ALERT SERVICE BULLETIN

Diamond
AIRCRAFT

Service Bulletin No.: DA20-28-02A, Rev. 0

Title: Fuel System Indicating and Storage

Figure 1

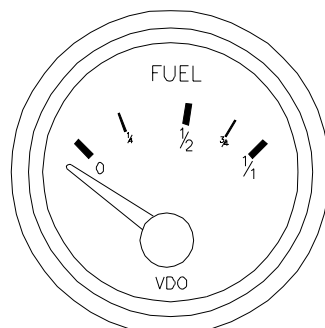
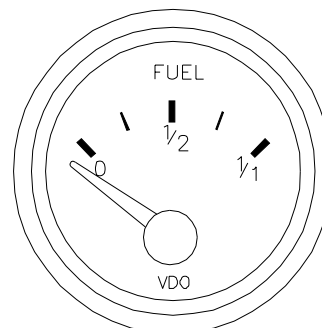
10.1.1 Refer to figure 1 to determine the type of fuel gauge installed on the aircraft.

10.1.2 If the obsolete gauge is installed contact Diamond Aircraft Customer Support to order a replacement gauge.

Part 1: Fuel Quantity Gauge P/N 301-035SB if required.

Figure 2.

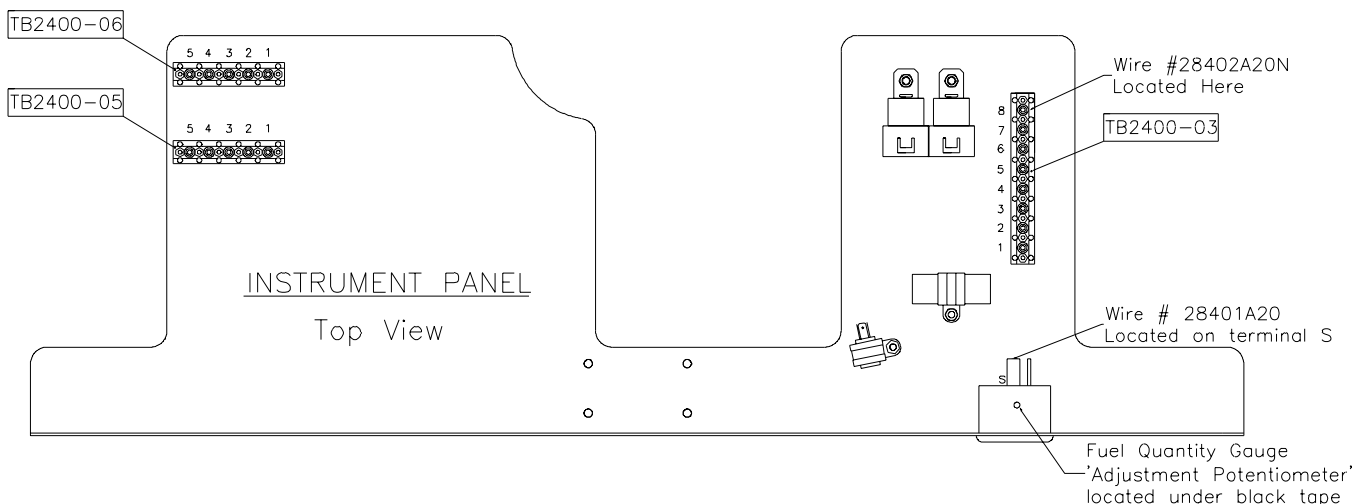
- 10.2.1 Disconnect the battery.
- 10.2.2 Completely drain the fuel tank. Residual fuel is drained via the quick drain.
- 10.2.3 Remove the instrument panel cover.
- 10.2.4 Refer to wiring diagram 20-2400-00-00 sh. 1 & 2.
- 10.2.5 Disconnect J2400-02 from P2400-02 and inspect the connector contacts for cleanliness and condition. Examine the fuel sender signal wire contacts #12 and #13. Clean or replace contacts as necessary.
- 10.2.6 Reconnect J2400-02 and P2400-02.
- 10.2.7 Remove ground wire #28402A20N from Ground Bus TB2400-03 Terminal #8 (Ref. Figure2.).

10.2.8 Disconnect the signal wire #28401A20 from the fuel quantity gauge. Using a calibrated Ohm Meter, measure the resistance between the fuel signal wire # 28401B20 and the ground wire #28402A20N. See figure 2.

10.2.9 The resistance measured in 10.2.6 must be between 70-73 ohms. If the resistance is not between 70-73 ohms troubleshoot the wiring and fuel sender to correct the problem.

Figure 3

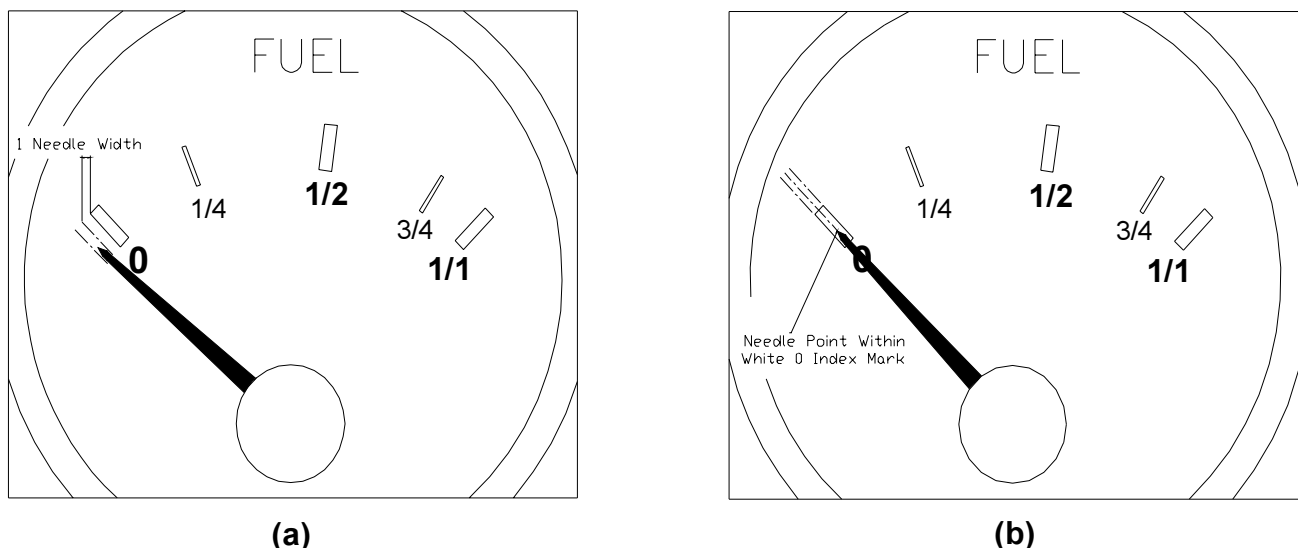
10.2.14 Adjust the fuel quantity gauge calibration potentiometer, shown in figure 2, so that the needle edge is one needle width below the 0 index mark as shown in figure 3a. Tap the fuel quantity gauge lightly, while adjusting, to remove any friction error.

10.2.18 Run the engine (or connect a 14 volt power supply to the aircraft electrical system). With the generator on line the needle point must be inside the 0 fuel mark on the fuel quantity gauge as shown in figure 3b. Continue tapping the indicator lightly if necessary.

Figure 4

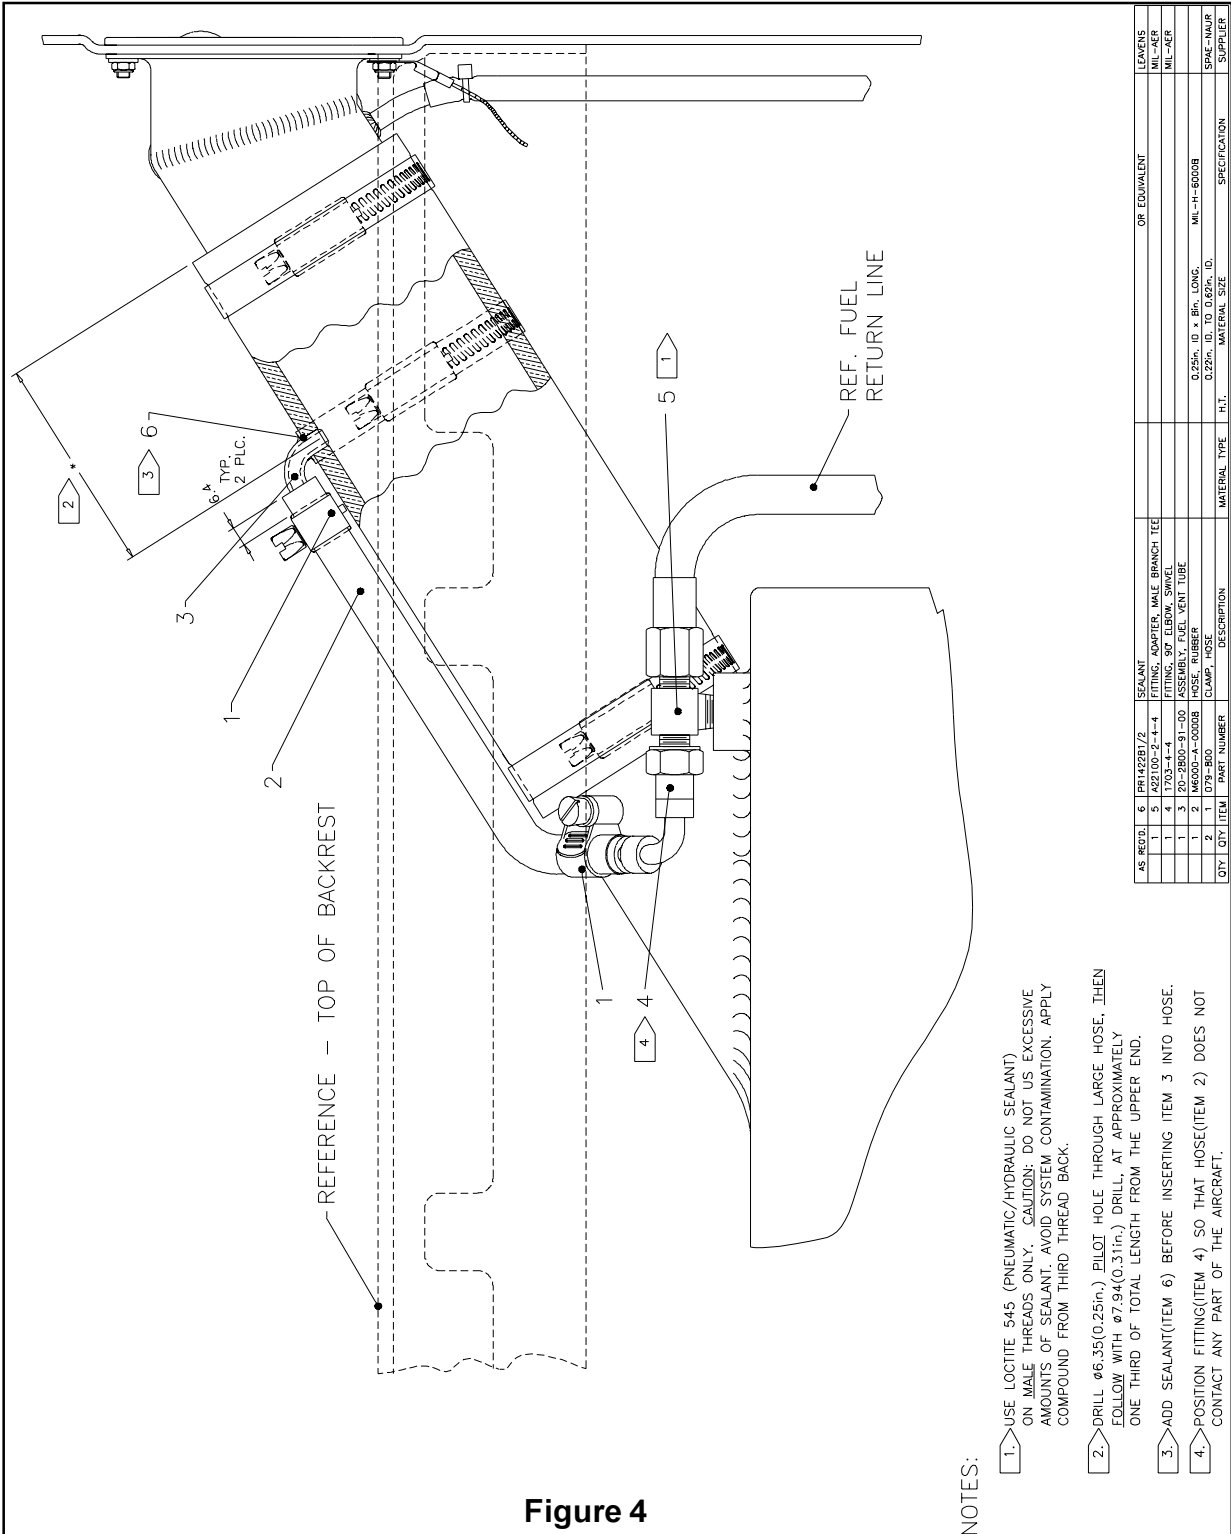
10.3.8 Drill a 1/4" hole in the rubber filler neck, located as shown in figure 4. Open up the hole with a oversize drill bit as described in figure 4, note 2.

10.3.10 Apply a small bead of PRC 1422B1/2, or equivalent sealant, around the 1/4" hole drilled in the rubber filler neck.

10.3.11 Install the fuel vent tube assembly to the rubber filler neck. Do not distort the filler neck by over tightening.

10.3.12 Assemble the fittings, hoses and clamps as shown in figure 4.
